Response to Reclamation Permit Application Consideration

RE: **Ogilvy River Farm Gravel Pit, M-2024-006**

CONDITIONS FOR APPROVAL

Map Viewer

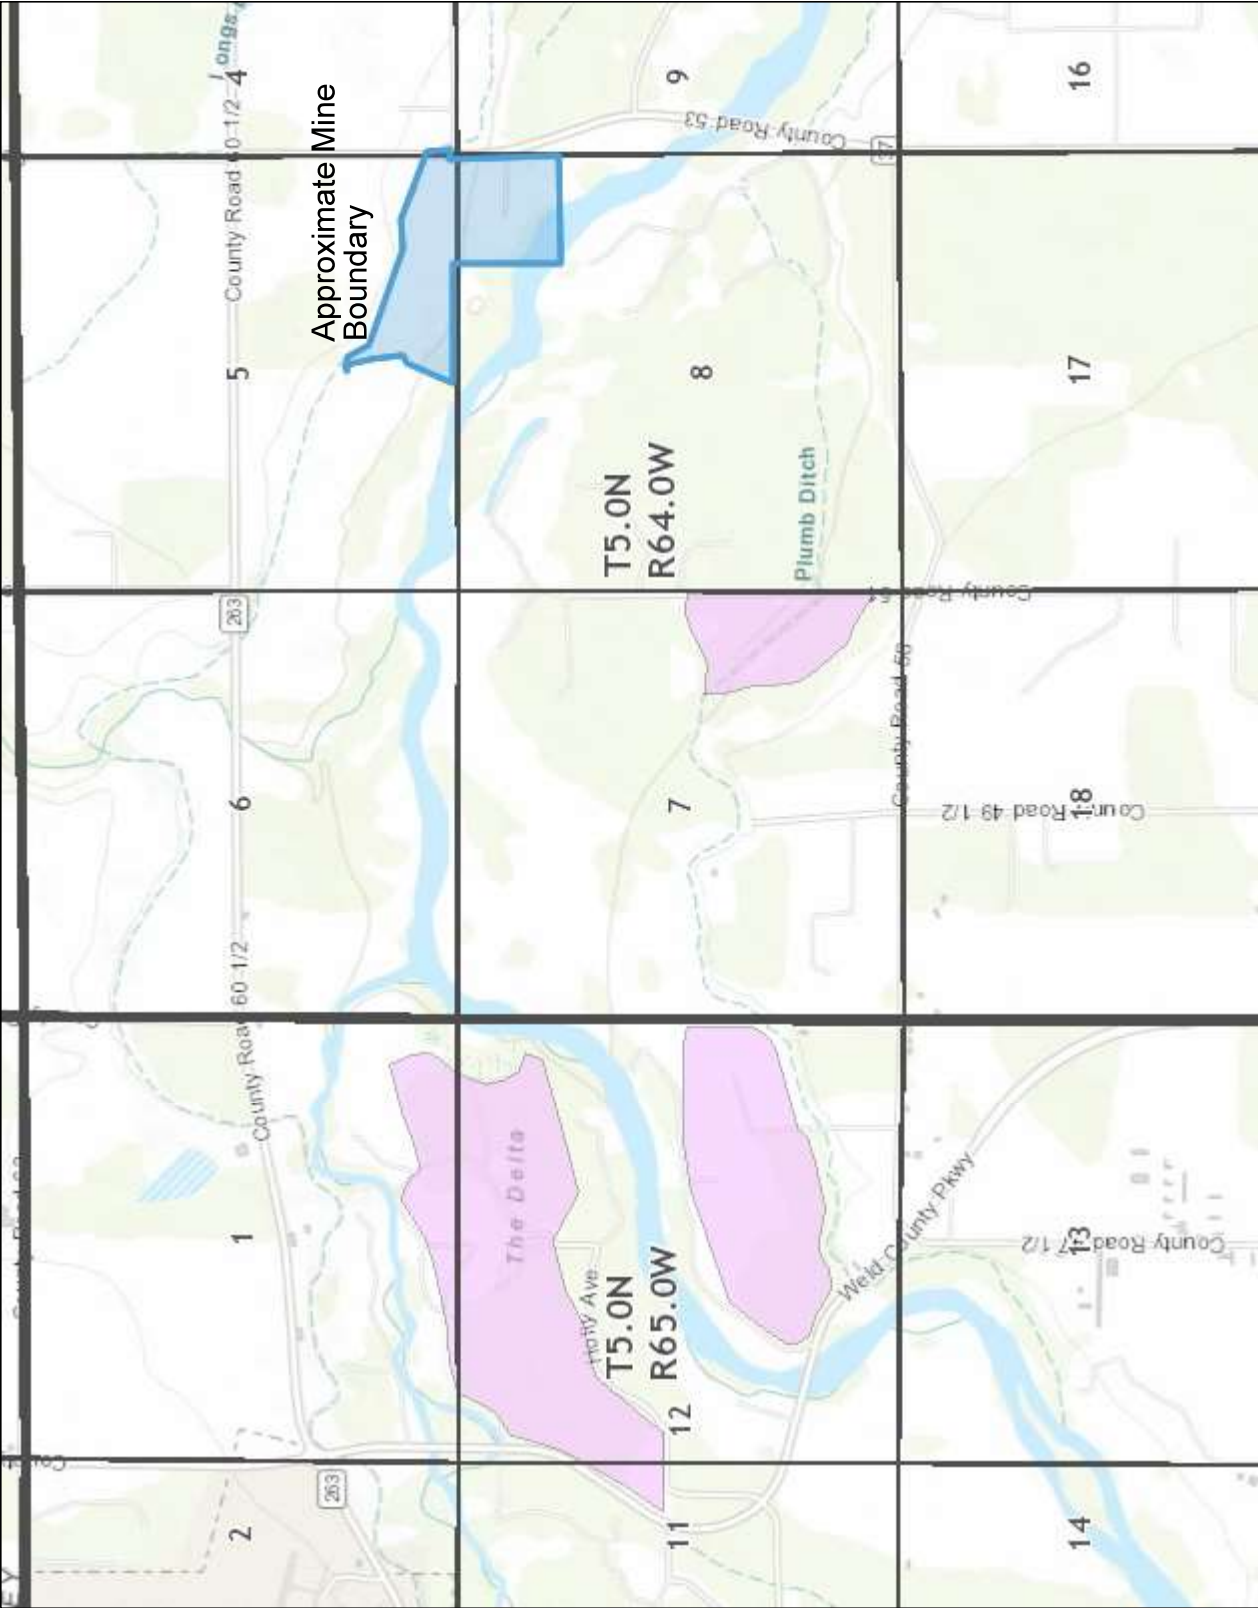
Additionally, in certain areas of the South Platte River Basin, SEO staff have observed groundwater problems that appear to be related to the lining of gravel pits located near streams, and in particular, these problems occur when multiple liners are located adjacent to each other. Attached is a map showing the location of this proposed mine and existing lined pits. DRMS should consider the siting and design of lined gravel pits to ensure that they will not individually or cumulatively result in impacts to the timing and quantity of groundwater flow from upgradient locations back to the stream system. In addition to impacts to property, such as flooding upgradient and reduced water levels downgradient of the liner, there are decrees of the court that specify the timing, quantity, and amount of water depleted from the streams by wells and accreted to the stream through recharge operations. The installation of a gravel pit liner should not result in changes to the timing, location, and amount of such groundwater flow. In the design and construction of the liner, the Applicant and DRMS should consider whether drainage structures are needed to allow water to flow back to the stream and to prevent water mounding behind the liner.
